TECHNICAL BULLETIN
014
December 2016

Check valve cages p.n. 1407.51

1407.51 was *1407.51 is*

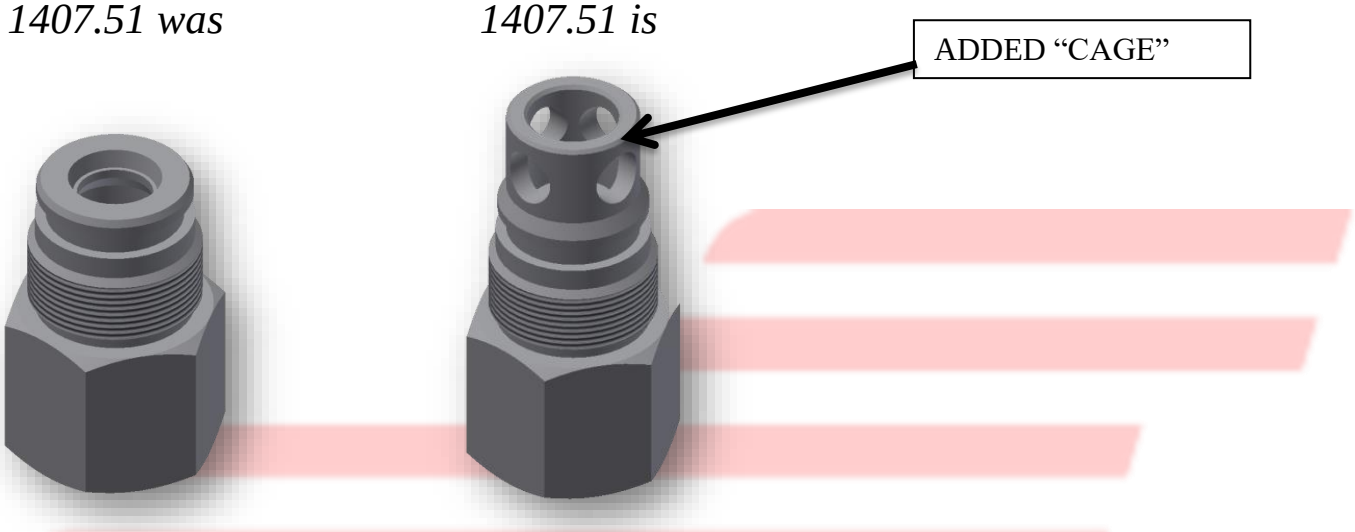
The fitting has been modified to improve the durability of the valve seat components in case of large flow rate in by-pass.
The new fitting is interchangeable with the old.
Other parts of the valve are not changed.
The part numbers remain the same.

Raccordo codici 1407.51

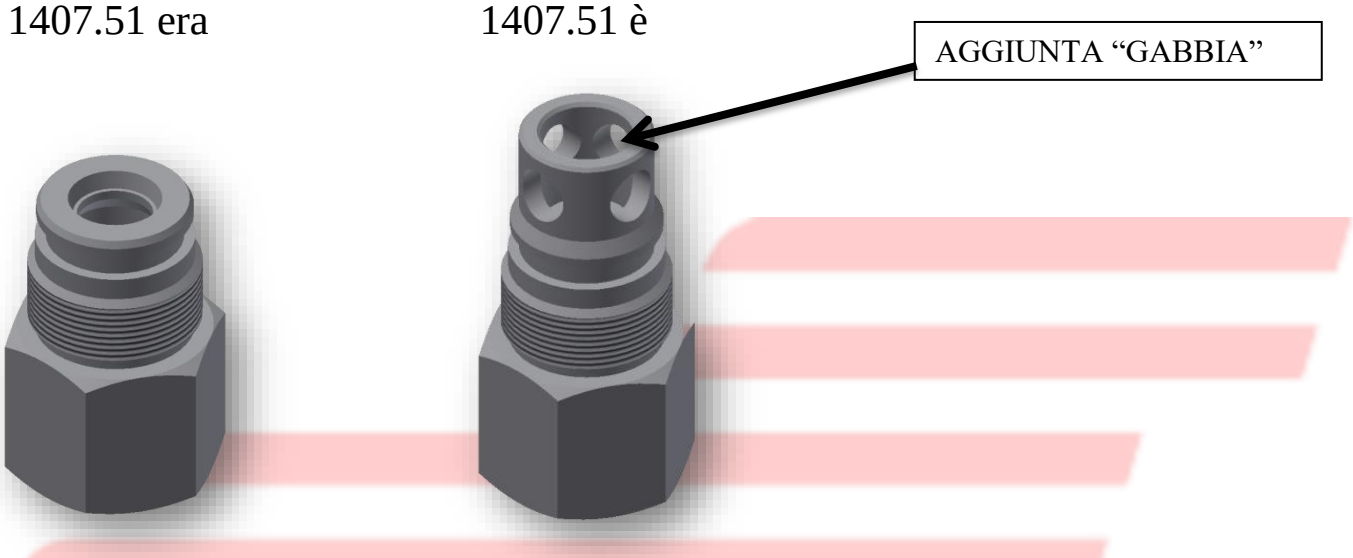
Il raccordo è stato modificato per migliorare la durata dei componenti della sede valvola nel caso di portata in larga parte in by-pass.
Il nuovo raccordo è intercambiabile con il vecchio.
Le altre parti della valvola non sono cambiate.
I codici rimangono gli stessi.
